## REVISED RESPONSE TO REQUEST FOR ADDITIONAL INFORMATION

### APR1400 Design Certification

Docket No. 52-046

RAI No.: 253-8300  
SRP Section: 03.07.01 – Seismic Design Parameters  
Application Section: 3.7.1  
Date of RAI Issue: 10/19/2015

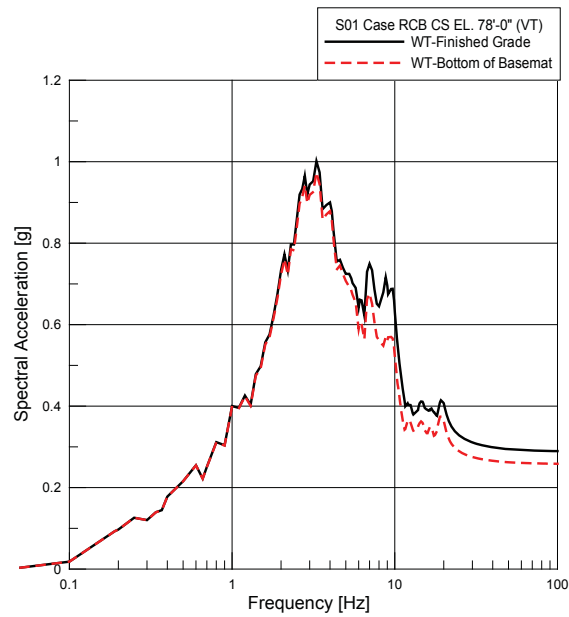
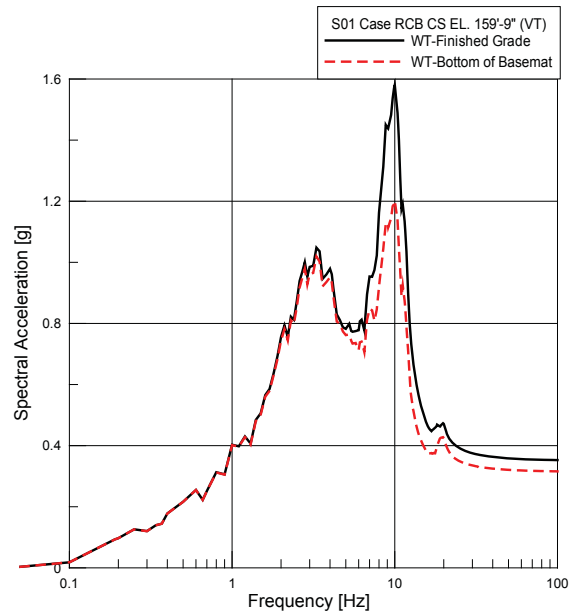
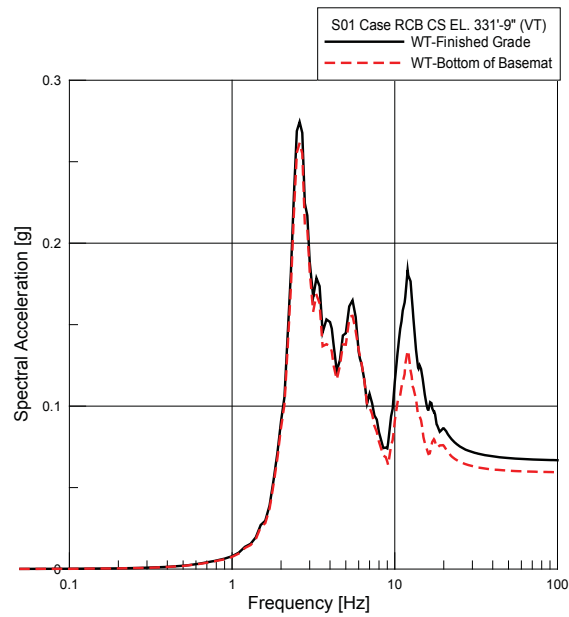
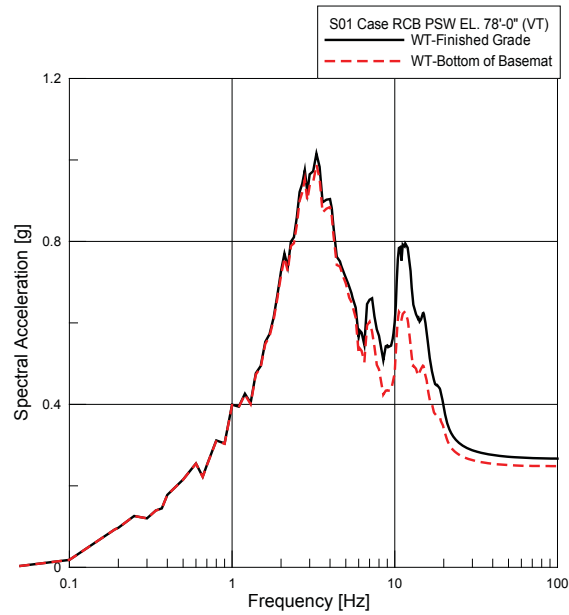
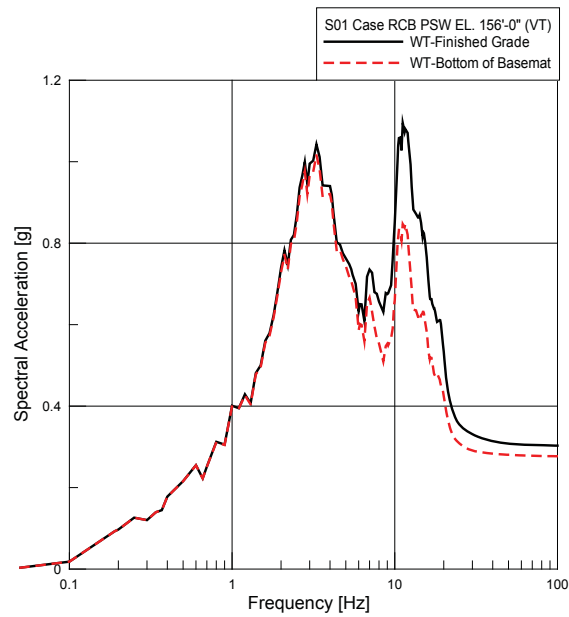
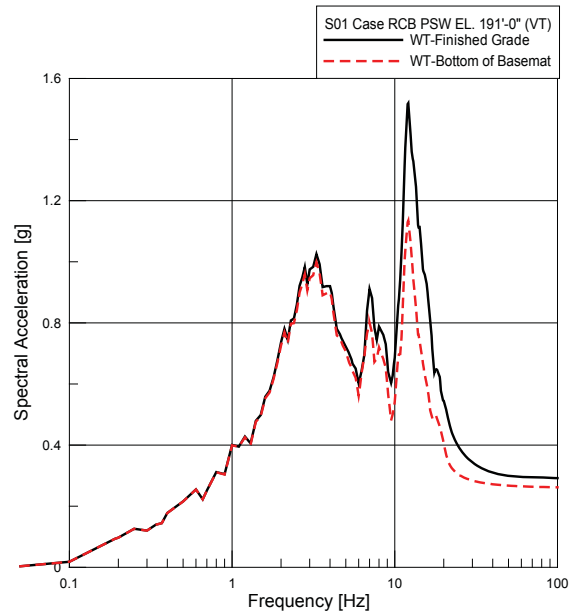
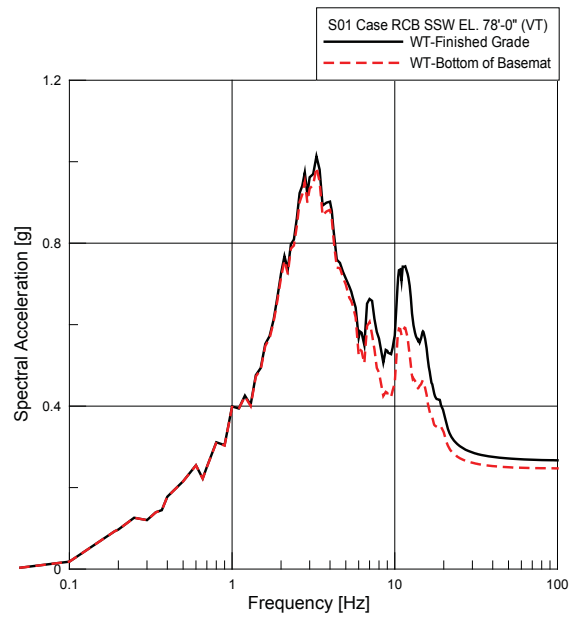
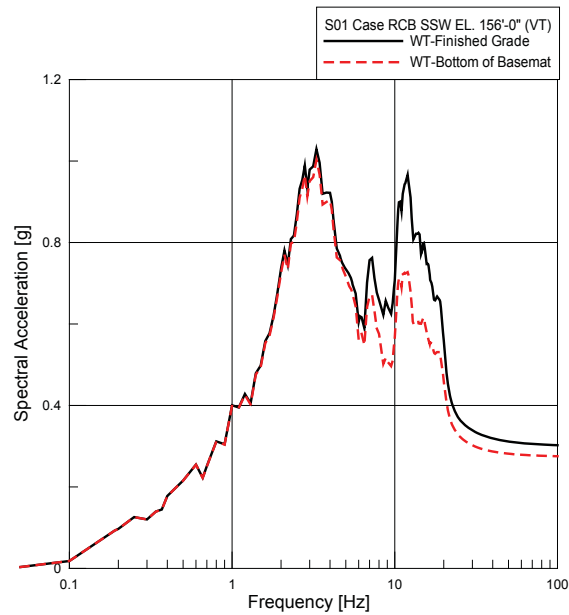
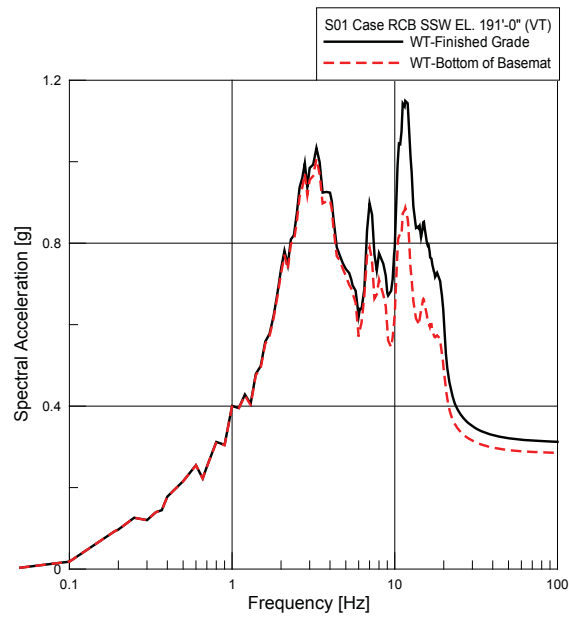
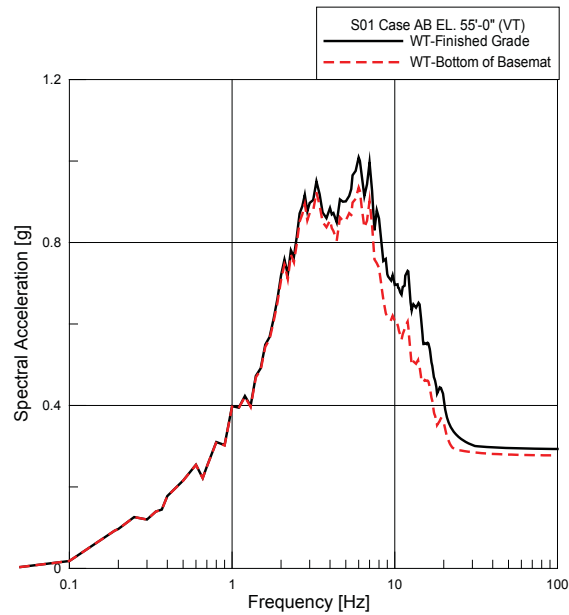
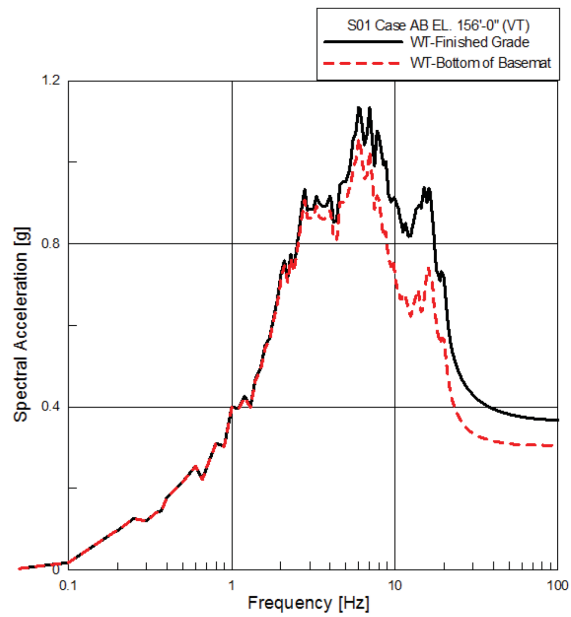
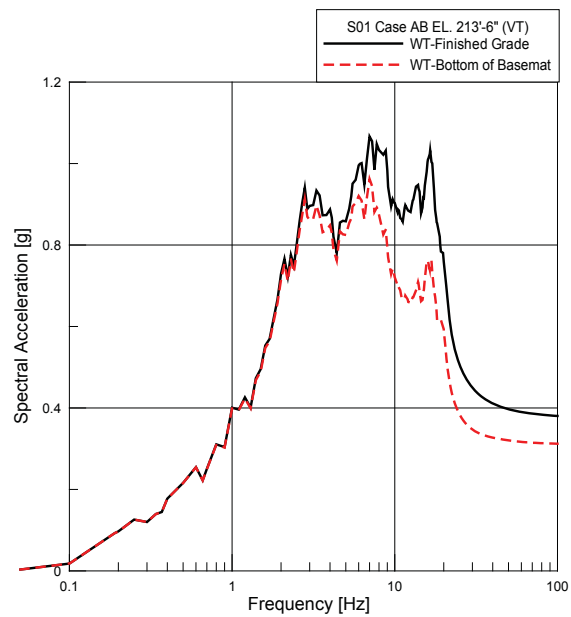
Section 5.1 of this report indicates that for the APR1400 standard design, the design ground water table is two feet below the ground surface (at El. 96'-8") and the extreme groundwater table is at the ground surface (at El. 98'-8"). The report does not specify how these two different water tables are used in the design/analysis of the APR1400 standard design. The applicant is requested to explain under what conditions is the design ground water table used and under what conditions is the extreme ground water table used, and to update the report as appropriate to incorporate this information.

- b) The design groundwater level, which is 2 ft below the ground surface (at El. 96'-8”), is used for calculating the hydrostatic load and the hydrodynamic load in the structural analyses, and the buoyant force in stability check of the seismic Category I structures for the overturning and the sliding. The extreme ground water level, which is at the ground surface (at El. 98'-8”), is used in the seismic analysis, buoyancy load calculation in the structural analyses, and the buoyant force calculation in stability check of the seismic Category I structures for flotation.

In the applicant’s experience, a higher groundwater level in the seismic analysis produces more conservative seismic responses than a lower groundwater level. Figures 1 through 12 show the comparison results of 5%-damped vertical in-structure response spectra (ISRS) of the S1 generic soil profile between different groundwater levels; one at the finished grade (ground surface at El. 98'-8”) and the other at the bottom of the NI basemat (El. 45'-0”). The results indicate that ISRS for the fully saturated soil case are more conservative.
